Top Cowl Air Deflector Kit – 135 thru 200

Mariner and Mercury 135-200

Cowl Deflector Kit P/N 818175A-1

Figure 1. Top Cowl Air Deflector

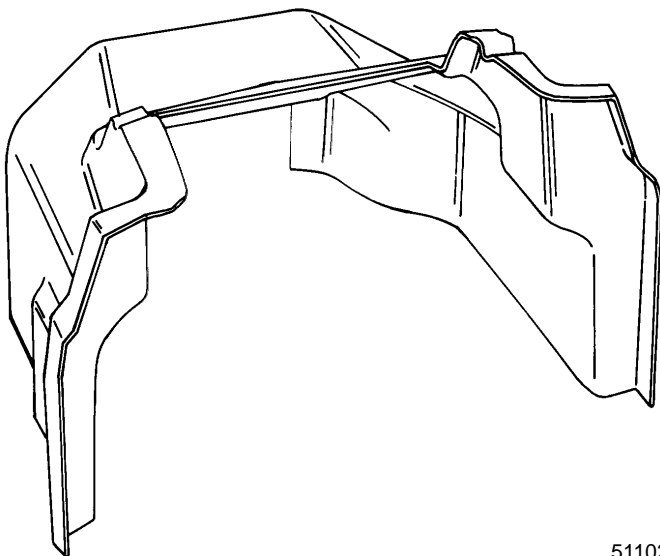
There have been instances where water has entered the area around the powerhead via the normal air inlets at the top of cowl. This condition appears on 40 amp models and most common in offshore/salt water applications. Water entry can cause a malfunction of the electrical and/or the ignition system. An indication of water entering the top cowl is corrosion on exposed electrical connections due to the salt water environment.

As a product improvement an air deflector is installed on 135 thru 200 models with the 40 amp alternator beginning with serial number OD050461. The air deflector can be installed to the models listed by ordering kit P/N 818175A1.

It will be necessary to remove some of the foam backing from the cowl to install the air deflector. The kit consists of: deflector, two (2) taller lower cowl drains, RTV sealer and instructions.
